# TOYOTA CUSTOMER SERVICES

04V-181

SUBJECT: SPECIAL SERVICE CAMPAIGN (SSC) - 40B  
(2001 TO EARLY 2004 MODEL YEAR TOYOTA HIGHLANDER CHILD PROTECTION  
LOCK SYSTEM)

**TECHNICAL INSTRUCTIONS**  
**FOR**  
**SPECIAL SERVICE CAMPAIGN 40B**  
**2001 – EARLY 2004 MY TOYOTA HIGHLANDER**  
**CHILD PROTECTION LOCK SYSTEM**

## II. LOCATION OF AFFECTED PARTS

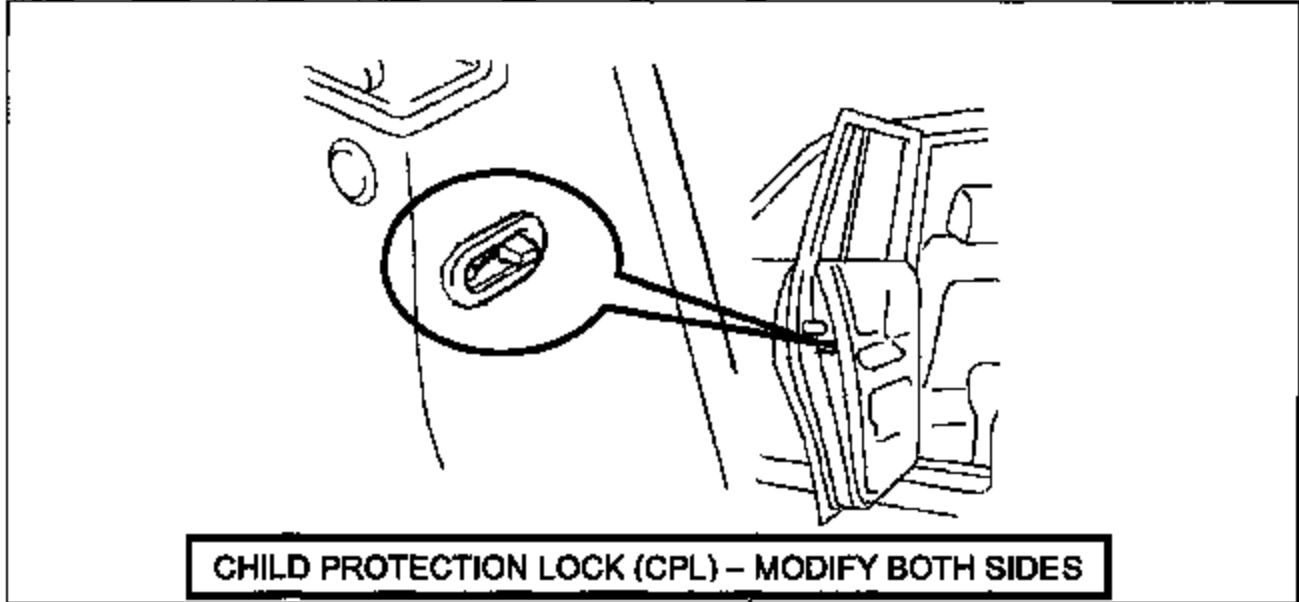
A2: There is an insufficient amount of clearance between the CPL lever and the body panel.

#### 2. INSTALL SUPPLIED SPACER.

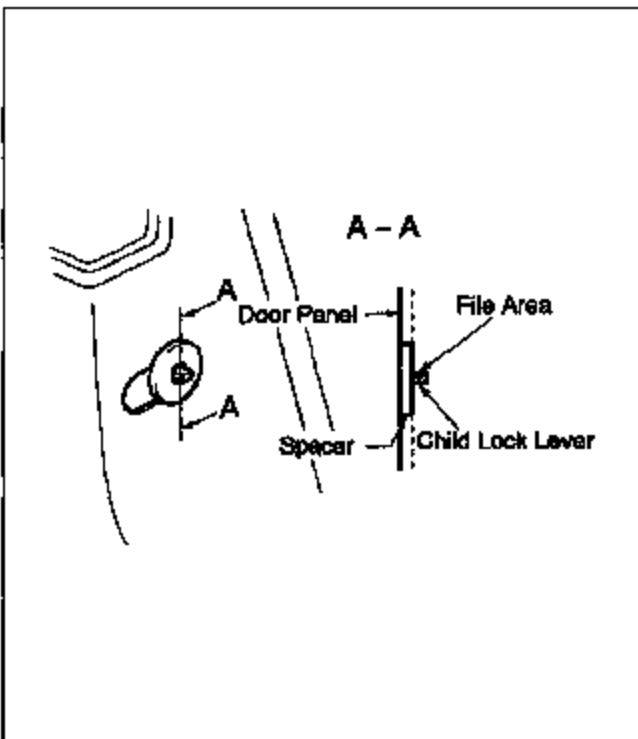
- Install protective tape on the door panel.
- Set the lock lever into the locked position.
- Install the provided spacer over the child protection lock lever as shown in the illustration.

**NOTE:** The supplied spacer may not fit flush against the door panel. The supplied spacer should bottom out on the lever.

#### 3. SHORTEN THE CHILD PROTECTION LOCK LEVER.

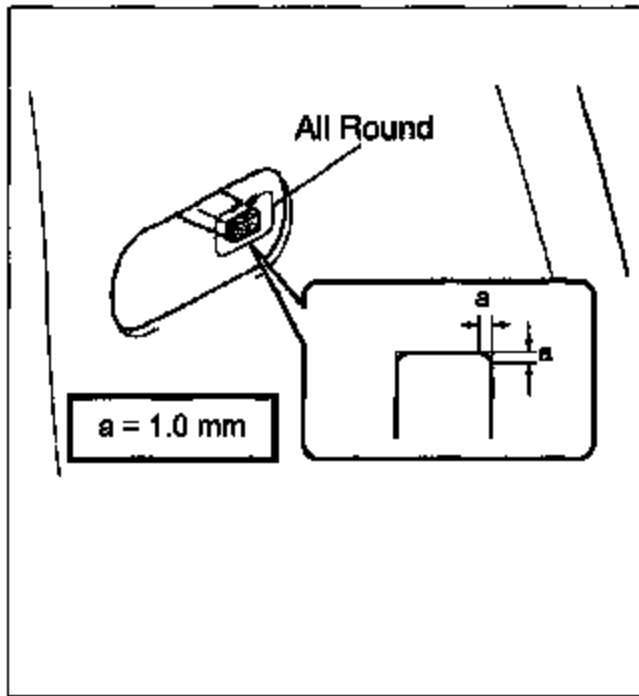
- Use a file or Dremel® to grind down the portion of the lever that protrudes from the spacer.

**NOTE:** If the lever is already flush or does not extend beyond the special tool (washer) the lever is okay and further modification for that particular lever is not necessary.
